Office Action Summary

10/727,809

LENK, FRITZ

DETAILED ACTION

Grieger

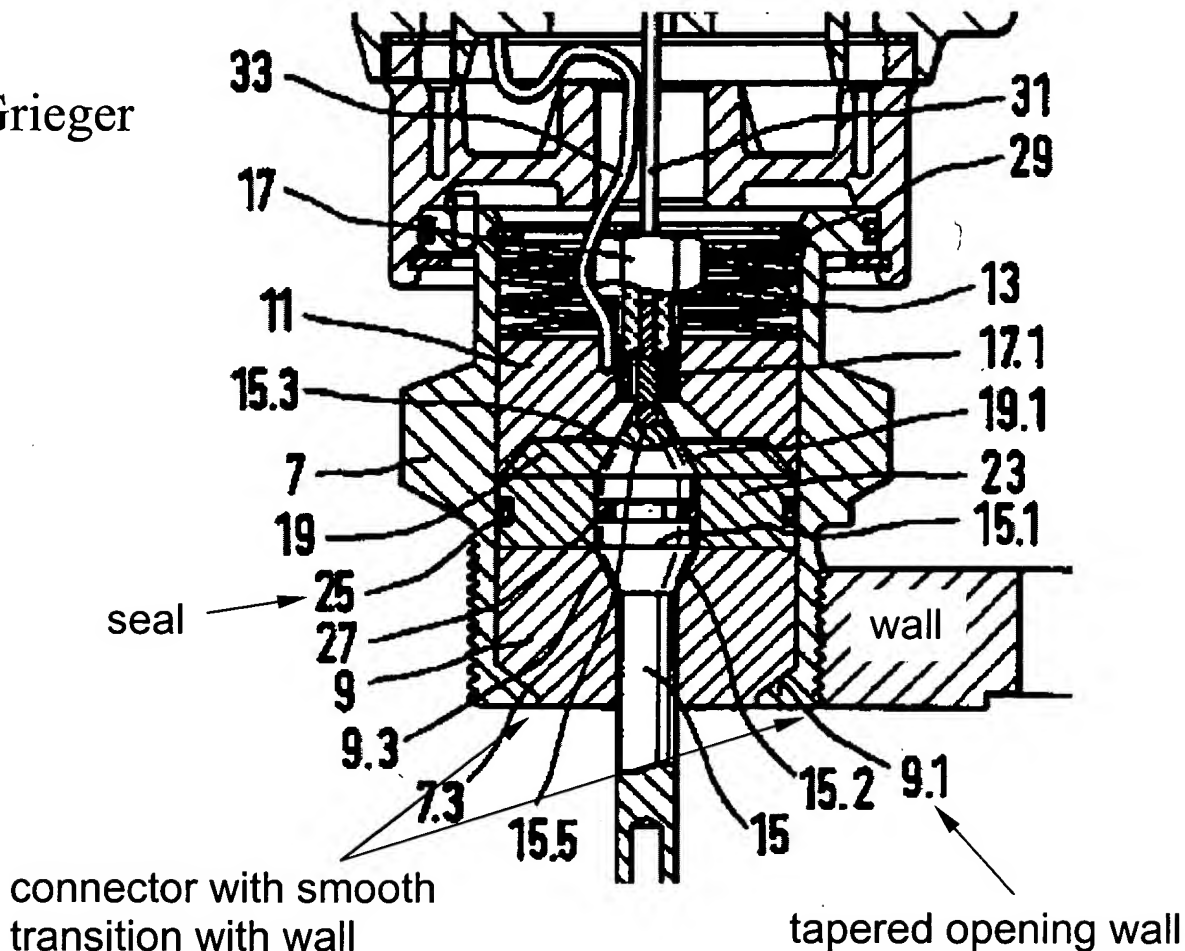
2. Claims 8 and 9 are rejected under 35 U.S.C. § 103(a) as being unpatentable over US 6,118,282 to Grieger. Grieger discloses a tank opening (Fig. 1) for accommodating a filling level measurement device having a passage opening between the outside of the tank and the inside of the tank sized for insertion of a filling level measuring device (1) and a seal (25) wherein the passage opening has, toward the inside of the tank, an opening wall (9.1) (see Fig. 1 below) protruding into the passage opening which at least partially tapers towards the inside of the tank (as recited in claim 8) and wherein the passage opening comprises a threaded connector towards the inside of the tank a smooth transition to the wall on the inside of the tank. Grieger further disclose that the connector may be attached to the tank via other well known methods to one of ordinary skill in the art such as welding (Grieger: col. 4, lines 4-6).

Fig. 3A

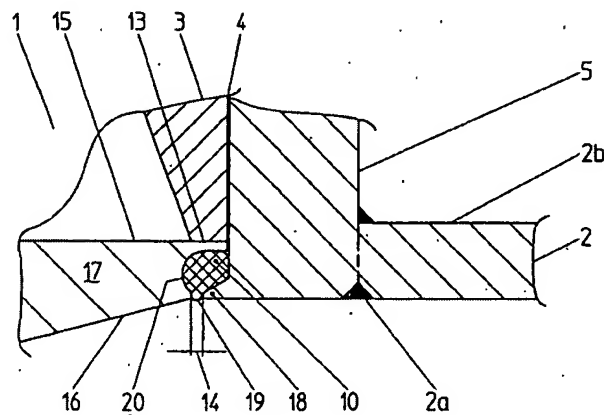
3. Claims 1-7 are allowed over the Prior Art of record.
4. Claims 10 and 11 are objected to as being dependent upon a rejected base claim, but would be allowable if rewritten in independent form including all of the limitations of the base claim and any intervening claims.
5. The following is a statement of reasons for the indication of allowable subject matter:
The Prior Art fails to disclose a tank opening or process for installing a level measurement

device having a clearance area (element 14 of Figure 3 of the instant application) with the seal pressing into the clearance area.
